Access Compliance Report

Public Rights-of-Way

(Curb Ramps)

Intersection ID: 10022294	Main Street: CAMBRIDGE_GREEN_DR	Cross Street: N/A	Location: E
ADA ID: FE21D46DEBDA	Ramp Type: Perp	Initial Pass/Fail: Fail	Overall Compliance: No
Severity Score: 21.25			
Codes/Mitigation Info/Possible Solution		Field Measurements/Component Compliance

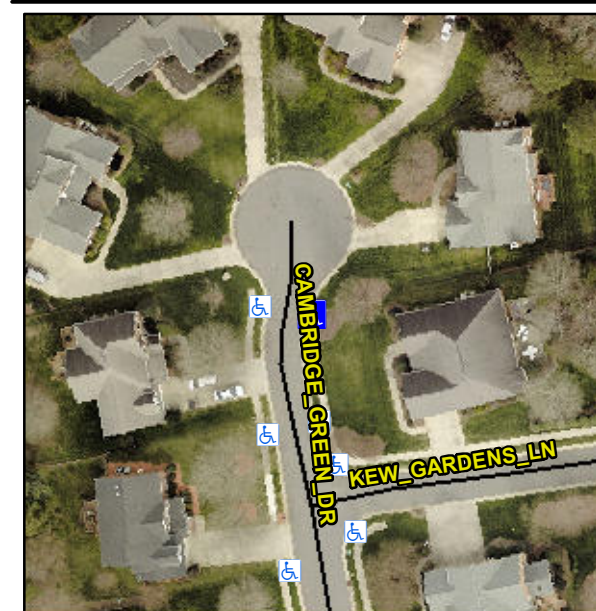
Remove & Replace Entire Ramp.

R304.5.1, R304.2.2

Compliance	Description	Data	Compliance	Description	Data
N/A	Ramp Length (in)	47.0	No	Ramp Slope (%)	10.9
No	Ramp Width (in)	44.0	Yes	Ramp XSlope (%)	2.0
N/A	Flare Type LT	N/A	N/A	Flare Type RT	N/A
N/A	Flare Slope LT (%)	N/A	N/A	Flare Slope RT (%)	N/A
N/A	Flare Traversable LT?	N/A	N/A	Flare Traversable RT?	N/A
N/A	Landing Length (in)	N/A	N/A	DWS Provided?	N/A
N/A	Landing Width (in)	N/A	N/A	DWS Contrast?	N/A
N/A	Landing Slope (%)	N/A	N/A	DWS Length (in)	N/A
N/A	Landing X Slope (%)	N/A	N/A	DWS Full Width?	N/A
N/A	Landing Curb? (Y/N)	N/A	N/A	DWS Offset (in)	N/A
N/A	Shared Landing?	N/A			
N/A	Gutter Ponding?	N/A	N/A	Gutter Slope (%)	N/A
N/A	Gutter Lip Ht (in)	N/A	N/A	Gutter X Slope (%)	N/A
N/A	Painted X Walk1?	No	N/A	Painted X Walk2?	N/A
	X Walk 1 Direction	To W		X Walk 2 Direction	N/A
N/A	X Walk 1 Width (in)	N/A	N/A	X Walk 2 Width (in)	N/A
	X Walk 1 Slope (%)	3.4		X Walk 2 Slope (%)	N/A
	X Walk 1 X Slope (%)	1.4		X Walk 2 X Slope (%)	N/A
